Manual Seat Track Forward/Rearward Adjustment Function Inoperative

Service Category Vehicle Interior

Section Seat

Figure 1.

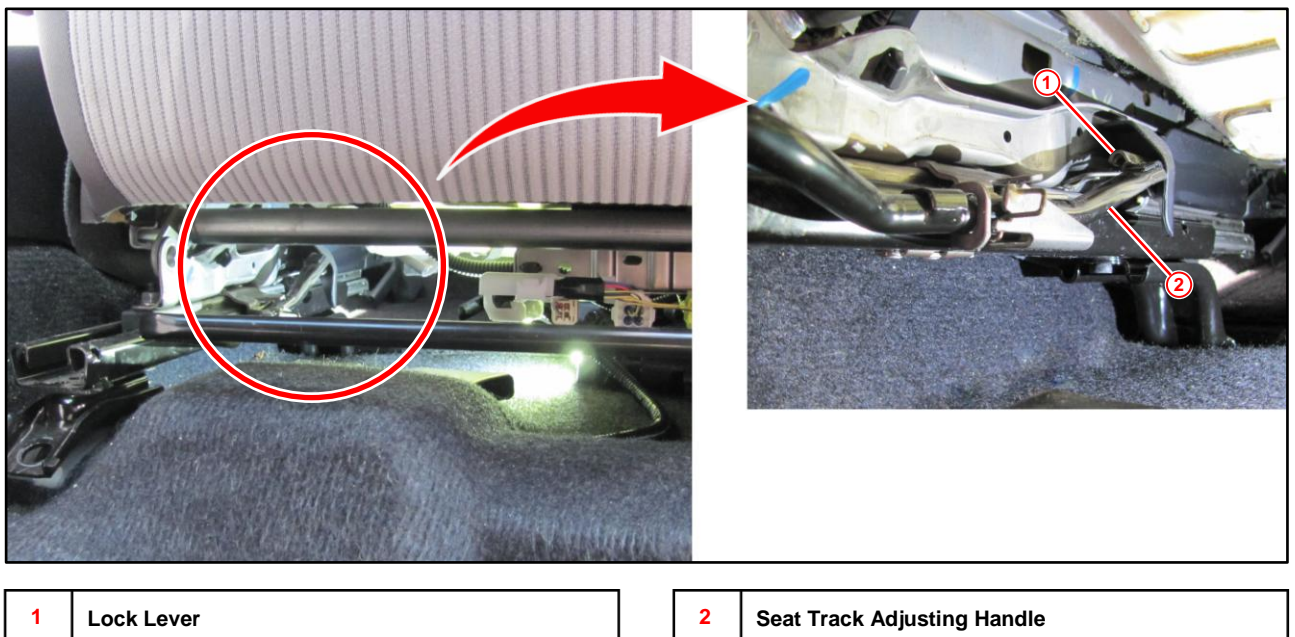
Some North American produced RAV4, Highlander, Highlander HV, and Sienna vehicles equipped with manual front seats may exhibit an inoperative forward/rearward adjustment function. Upon closer inspection it may be noticed that the Seat Track Adjusting Handle has become disengaged from the locking levers. Follow the Repair Procedure in this bulletin to address this condition.

Figure 3.

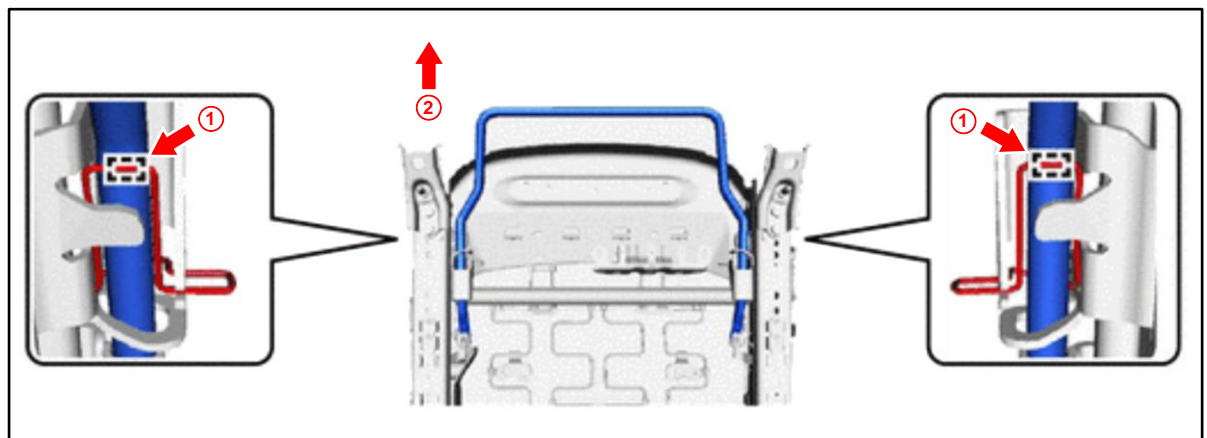
- A. Detach the 2 hooks to remove the Seat Track Adjusting Handle in the direction indicated below.

Figure 4.

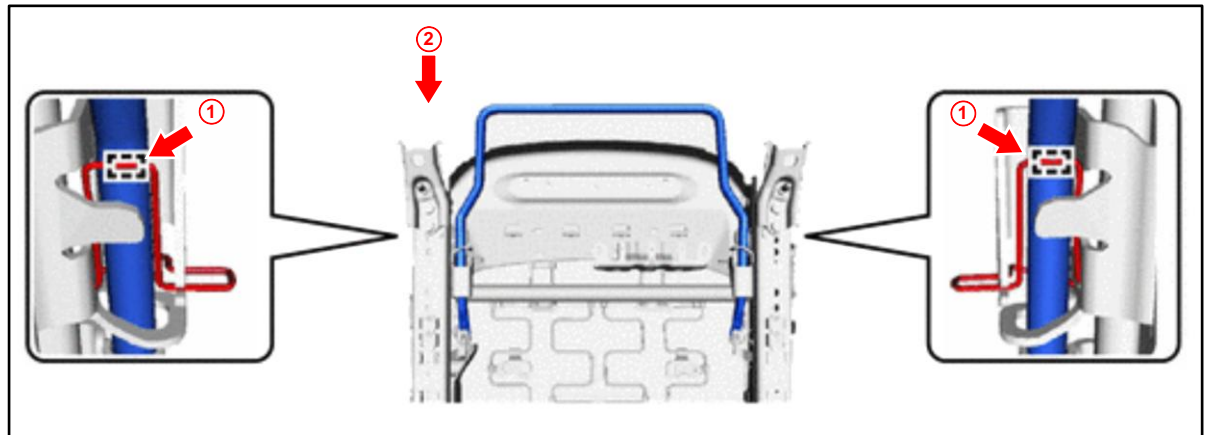
- B. Attach the 2 hooks to install the Seat Track Adjusting Handle in the direction indicated below.
